TECHNICAL MEMORANDUM

Project	11863 M002		
Date	11 October 2019	Memo No	M002
Memo to	Mark Berry (JSA Planning)	Copies to	
From	Michael Cheong MIOA	Checked by	Adrian James FIOA
Filename	11863 M001.docx

We have been appointed by Grundon Waste Management Ltd to undertake a noise assessment for a proposed residential development at Higham Way, Banbury. The site is predominantly brownfield with noise from a number of sources including the M40 approximately 950m east of the site, a railway line to the South of the site, and the Chiltern Railway's Light Maintenance Depot (LMD) which operates primarily at night.

Figure 1 -Statistical distribution of daytime background sound levels (LMD noise excluded)

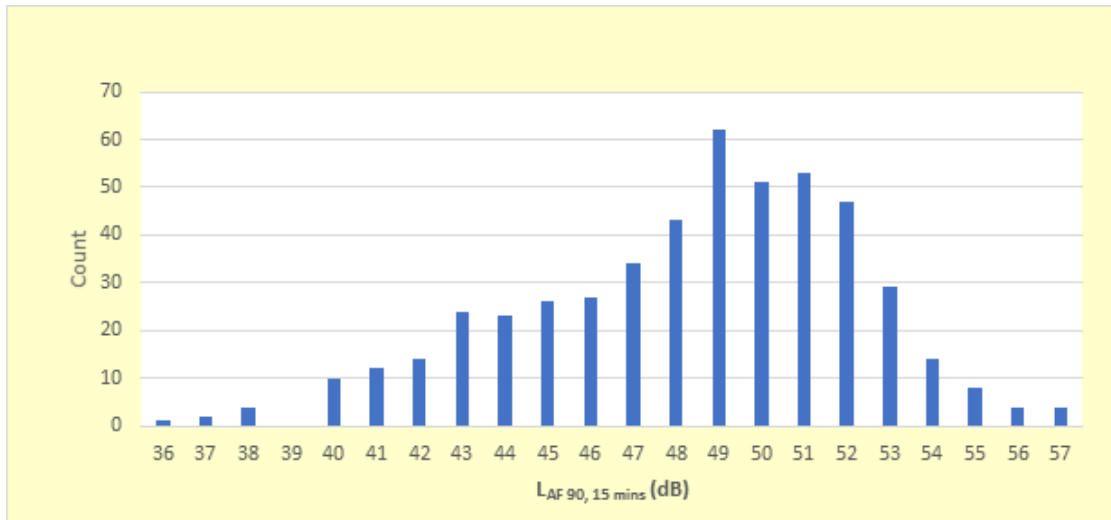
"In answer to my previous questions on this AJA have confirmed they have taken the average for each day and night time monitoring period and referred to figures 8, 9, 10 and 11 in the report. What I was after was the range of levels measured during the night time periods in particular, to be clear that a representative level has been used and not just the average for the monitoring period."

We have followed this guidance. Figure 1 shows the statistical distribution of daytime background sound levels with the noise from the Light Maintenance Depot excluded. The distribution shows a peak (the mode) at 49 dB $L_{AF90,15 \text{ minutes}}$. However we have selected 45dB $L_{AF90,T}$ as the representative background sound level as this provides a robust assessment of the noise. This is well below the mode, the linear average and the logarithmic average value.
